## PUBLIC HEARING MEMORANDUM

SUBJECT: **Petition #229-20**, for SPECIAL PERMIT/SITE PLAN APPROVAL to allow a four-unit multi-family dwelling, to extend nonconforming front and side setbacks, and to allow a retaining wall in excess of four feet within the setback at **13-17 Gardner Street**, Ward 1, Newton, on land known as Section 11, Block 25, Lot 05 and Section 11, Block 25, Lot 06, containing approximately 16,579 sq. ft. of land in a district zoned MULTI RESIDENCE 2. Ref: Sec. §3.2.6, §3.4.1, §5.4.2.B, §7.3.3, §7.8.2.C.2, and §7.4 of the City of Newton Rev Zoning Ord, 2015.

**13 and 17 Gardner Street**

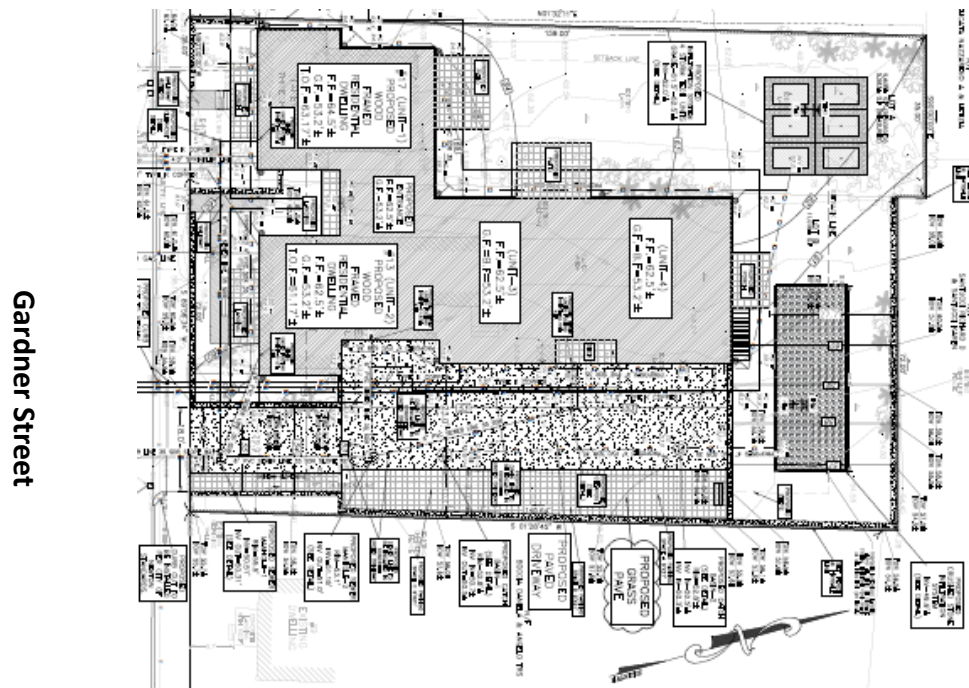
The petitioner is proposing to raze the existing dwellings to construct a four-unit multi-family dwelling. The multi-family dwelling would incorporate the architecture and the location of the existing structures. Specifically, the two units fronting Gardner Street are similar in scale and massing and have a similar presence on the street. These units would also have a setback of 1.9 feet from the western boundary, where 7.5 feet is the maximum required. Because the proposed multi-family dwelling would be similar in scale and largely constructed on the footprint of the existing structures, staff believes the location within the side setback is appropriate.

The multi-family dwelling would feature an internal landing connecting the two front units and then extend the footprint in the form of rear “ell” addition, containing two dwelling units. The addition would extend the footprint of the structure approximately 70 feet to the rear, resulting in a rear yard setback of 31.2 feet, where

**Proposed Site Plan**

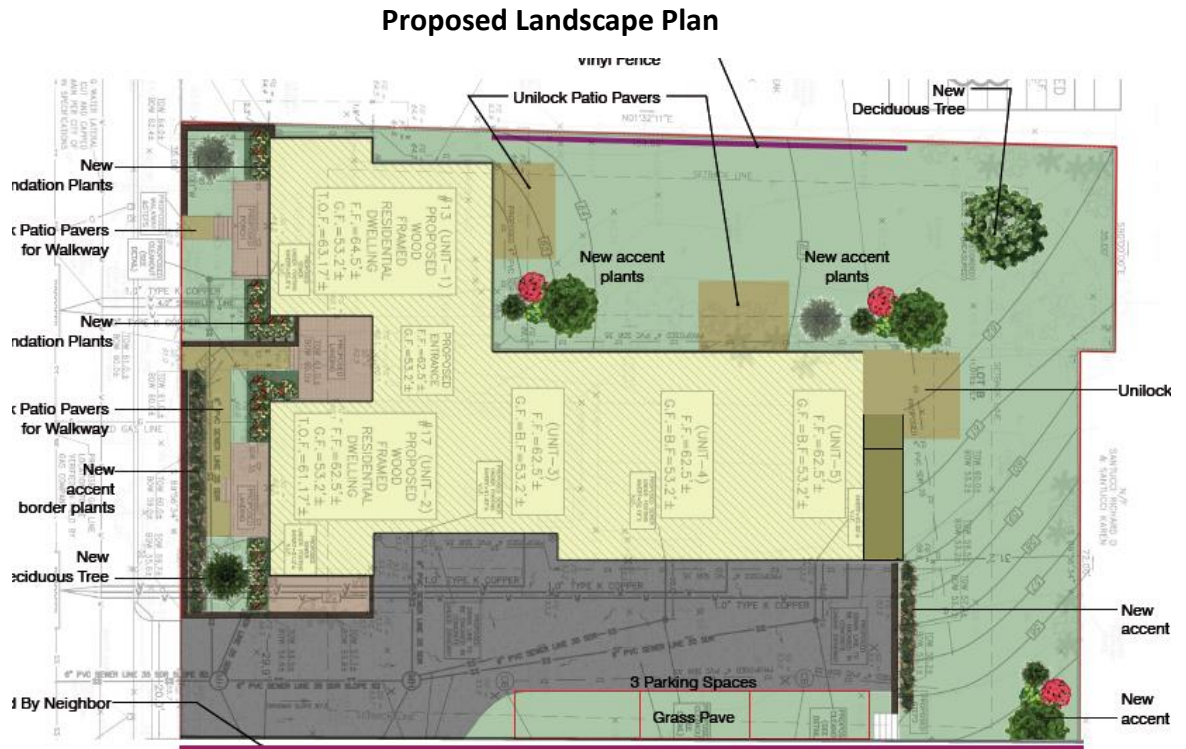
15 feet is required. The rear addition scales to approximately 35 to 40 feet from the side lot lines, where 7.5 feet is the maximum required. The driveway would be shifted approximately 15 feet towards the eastern boundary, providing access to eight garaged parking stalls in the basement of the structure as well as three surface parking stalls on grass pavers. A retaining wall of 4.1 feet in height is required to allow for the driveway to slope down into the lot, and its location within the front setback requires a special permit. The Planning Department is not concerned with this wall due to the grade of Gardner Street and because a retaining wall already exists in this location. An additional retaining wall would be located at the eastern boundary, but this wall does not reach four feet in height. The petitioner is not proposing much site work elsewhere on site.

The petitioner is proposing to push the driveway to the eastern boundary to provide access to the garages in the basement. The Planning Department suggests that the petitioner consider extending the lawn area at the eastern boundary to the sidewalk to reduce the amount of paving and to reduce the width of the curb cut. Each of the units will have room for two cars park in their dedicated garages as well as an additional three spaces along the eastern boundary, on proposed grass pavers indicated in the landscape plan. The Planning Department has concerns with the additional three stalls indicated on the landscaping plan beyond the required number of stalls. The petitioner should provide turning templates for the stalls exiting the garage. The site is located within walking distance of amenities and bus transit on Washington Street and nearby Nonantum.

The existing curb cut at the western boundary provides access to 17 Gardner Street over the adjacent property at 21-25 Gardner Street. Because the petitioner no longer requires this access, the Planning Department suggests that the petitioner use good faith efforts to work with the abutter to close the curb cut.
